Rezoning Transportation Analysis

Petition Number: 2021-081

Date	Description
08-02-21	First Review (LH)

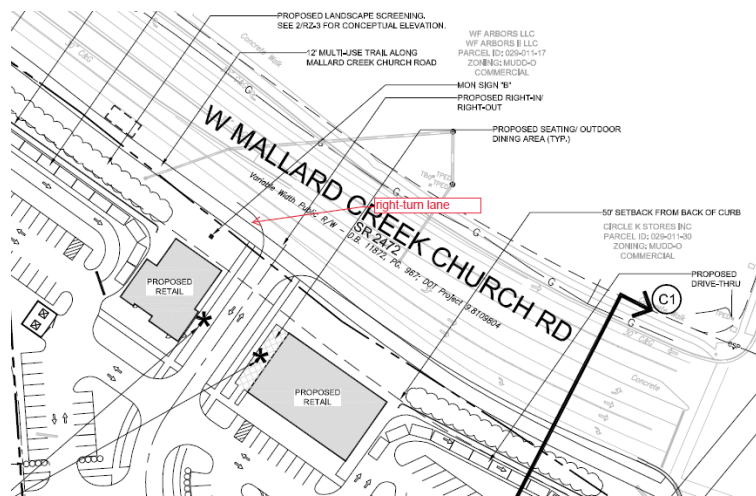
- Curbline:** The proposed zoning district has a setback measured from back of the existing or proposed future curbline.
- Traffic Study:**
~~Since traffic impacts have not changed for this site the previous rezoning petition, a Traffic Impact Study (TIS) is not necessary for the complete review of this petition.~~
- Per NCDOT coordination and review of this petition, the site plan and conditional note(s) revisions are needed to show the right turn lane from Mallard Creek Church Road into the site (see below):

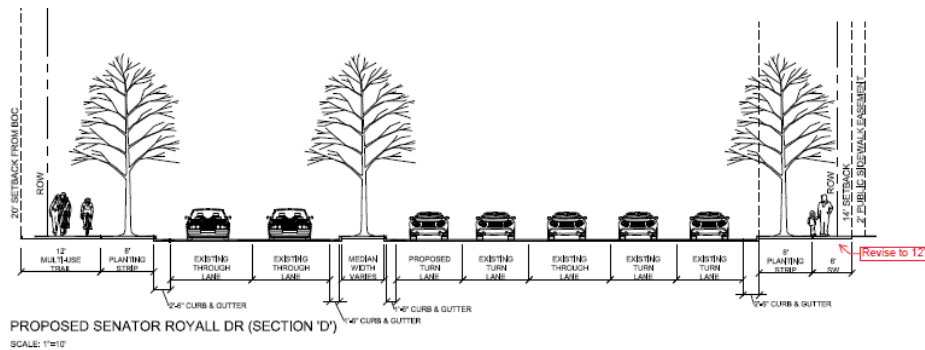
- Site plan and conditional note(s) revisions are needed to show the 12' MUP on both sides of the proposed Senator Royall Drive (Section D) – see below:
